City of Fayetteville, Arkansas

Planning Commission Tentative Agenda

Thursday, February 6, 2025

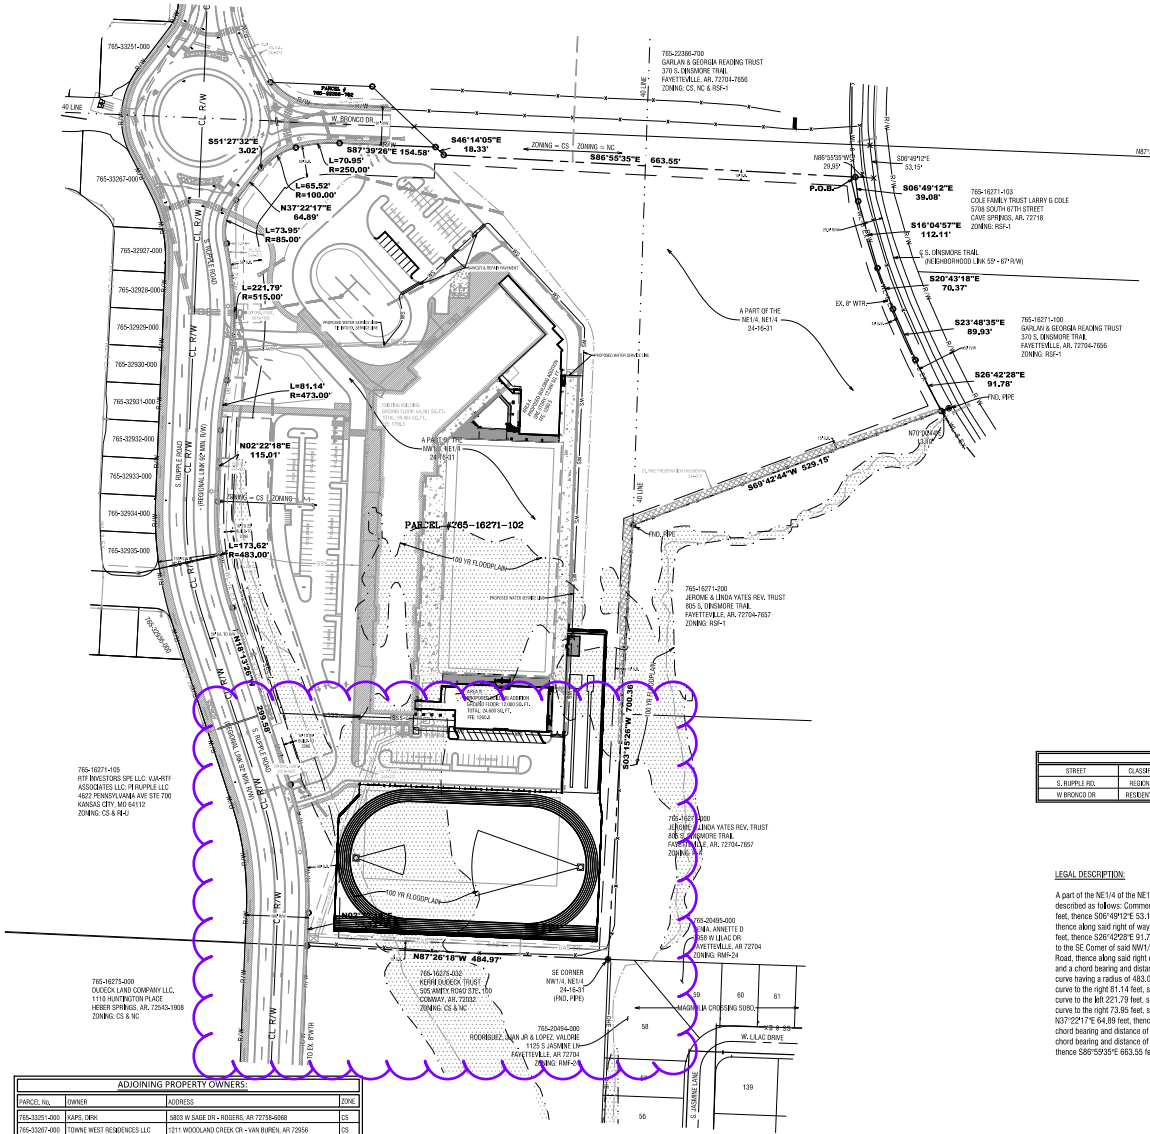
DISCUSSION:
Staff recommends approval of the applicant's request to amend their large-scale development as proposed. Pond 3 initially proposed to handle the added impervious are from the middle school expansion. However, with the revised plan to enlarge the track, the pond will be removed and replaced with an underground detention system./

Drainage: Previously, Pond 3 was proposed to be modified to accommodate the additional impervious area proposed with the middle school expansion. With the revised proposal to increase the size of the track, this pond is now shown to be removed and replaced with an ADS underground detention system with isolator rows to meet water quality requirements. Staff will review the revised drainage report with the grading permit to verify conformance with Minimum Standards 1-4 of the Drainage Criteria Manual.

The reason for this ADM is that the school has decided to expand the track from a 200 meter to a 300 meter track.

DATE: 2025-01-31
JOB NUMBER: 22-11352
DRAWN BY: L. Stewart
RECORDED BY: J. Du Quesne
DRAWING NAME: 22-11352 Civil 011.dwg
SHEET NUMBER: C5

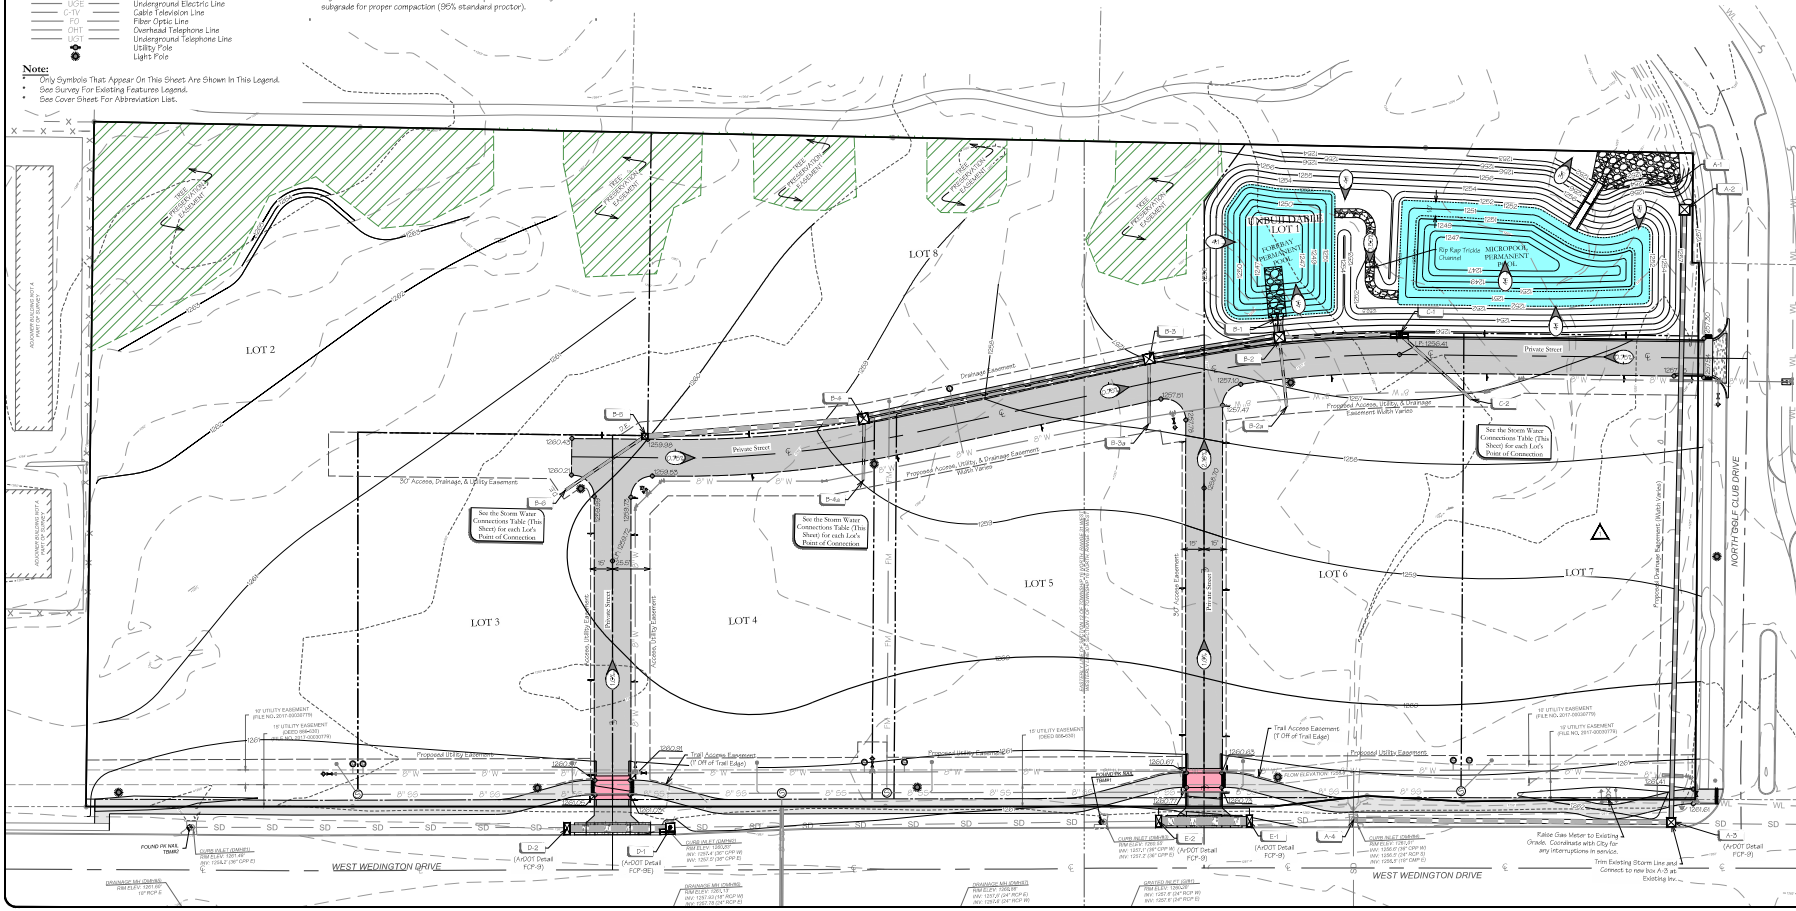
Sewer: Similar to water, sewer infrastructure is being installed with the grading permit to provide sewer service to the development. A 10-foot wide "flag" is shown on Lot 8 to facilitate direct frontage the sewer main being installed along Wedington Dr between Lots 4 and 5 to provide sanitary sewer service to the additional lot.

Drainage: The pond location for this development is shown to be relocated from the original approved location. Upon preliminary review, the development still appears to meet the four Minimum Standards of Fayetteville's Drainage Criteria Manual. A more detailed review will be performed with the revision review for GRD-2023-0053 to verify the modifications conform with all required criteria.

1. Additional review of the plans will be performed with the revision review for GRD-2023-0053, and comments or approval of the revisions will be issued with the grading permit following approval of this modification.
